COMMUNICATION from the City Plan and Zoning Commission advising that at a public hearing held on February 21, 2008, the members voted 12-0 in support of a motion to APPROVE the request from Cornerstone Family Church for approval of a preliminary subdivision plat for "Cornerstone Family Church Plat 1" for property located in the vicinity of 4375 SW 63rd Street subject to the following conditions:

APPROVAL of a PBP Conceptual Plan for "Cornerstone Family Church" located in the vicinity of 4375 SW 63rd Street to allow development of 16.3 acres for office/business park use and a four (4) acre outlot, subject to the following:
(ZON2007-00175)

APPROVAL of a preliminary subdivision plat "Cornerstone Family Church Plat 1", subject to the following:

ZON2007-00175

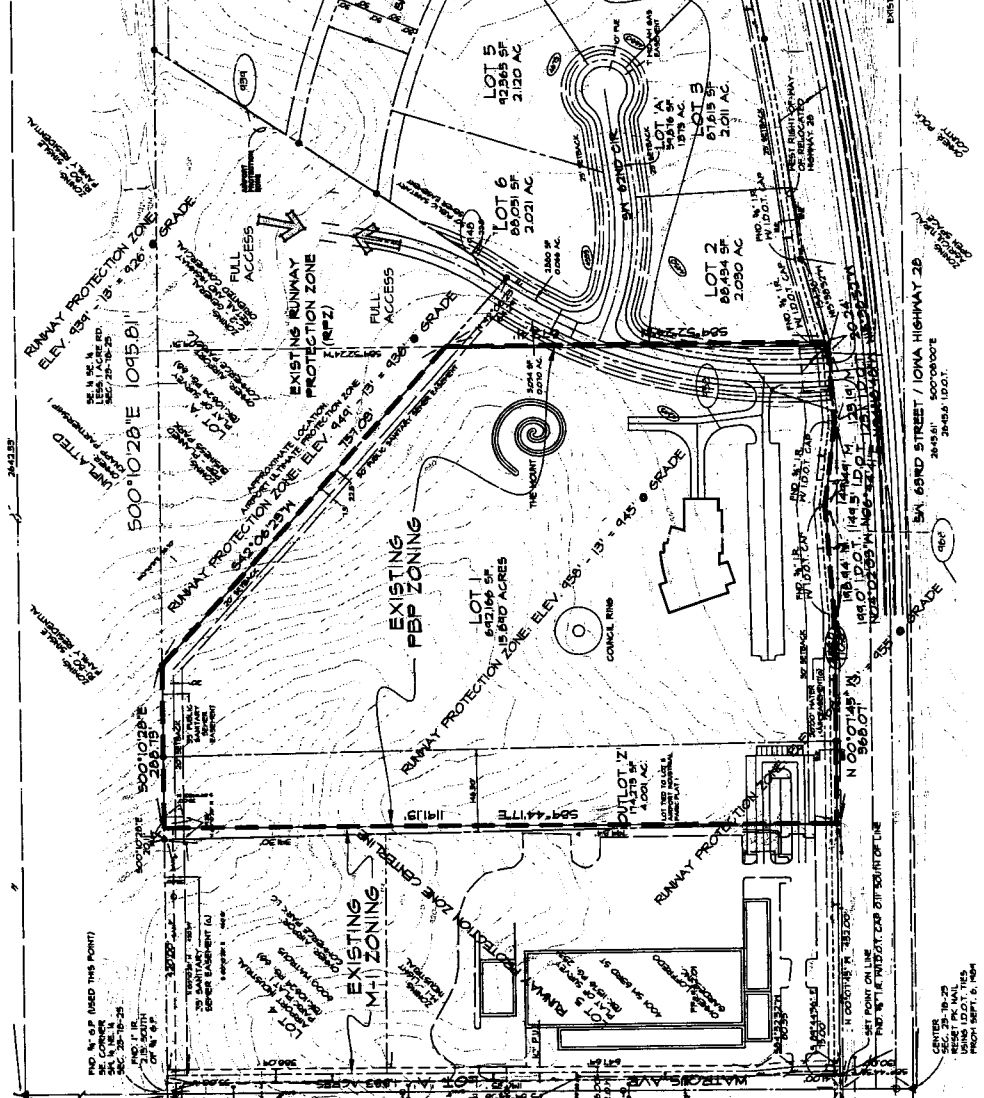
1. Prohibition of off-premises advertising signs.
2. Replacement of the opening statement under the *Development Standards* heading with the following: "All provisions of Division 14, PBP District Regulations, City of Des Moines Zoning Ordinance are incorporated as well as the following standards."

3. Removal of notes 1 through 6 under the *Development Standards* heading.
4. Addition of parking lot setback notes under the *Setbacks* heading as required by Section 134-739(3) of the Zoning Ordinance.

5. Provision of a 10' minimum parking lot setback from the south property line of Outlot Z.
6. Replacement of the *Planting Plan* statement under the *Landscaping* heading with the following: "A planting plan must be submitted as part of any Development Plan and must be signed by a landscape architect registered in the State of Iowa."

PRELIMINARY PLAT CORNERSTONE FAMILY CHURCH

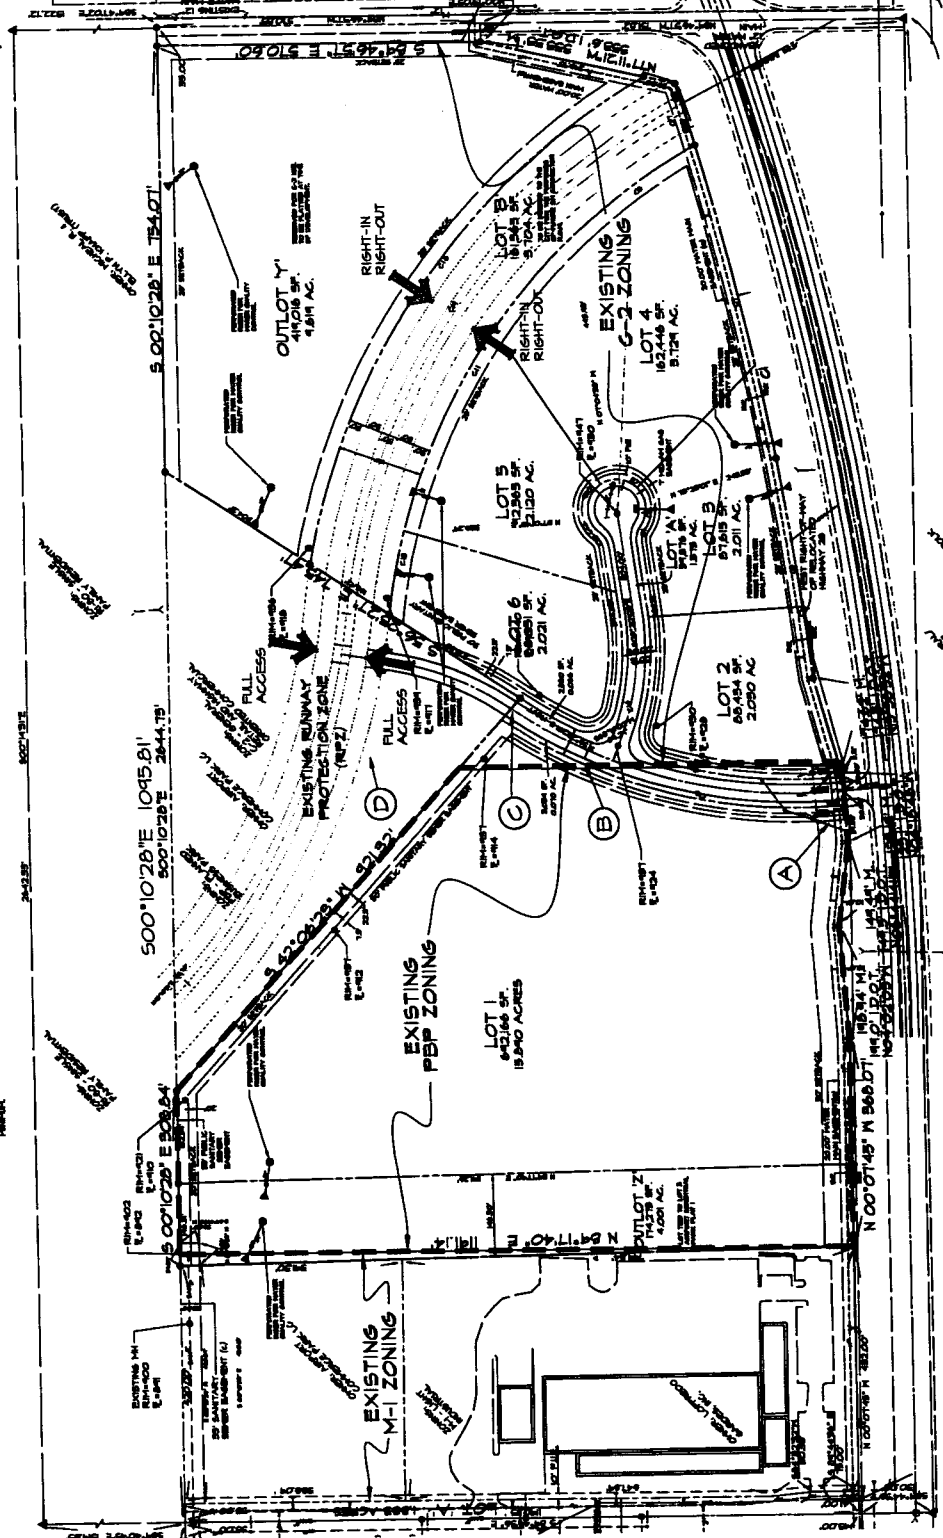
1. Compliance with all Preliminary Plat requirements of the Permit and Development Center.
2. Provision of covenants that Lots 1 through 6 are responsible for construction of the remaining portion of Stanton Avenue that will extend to the SW Connector in the future.
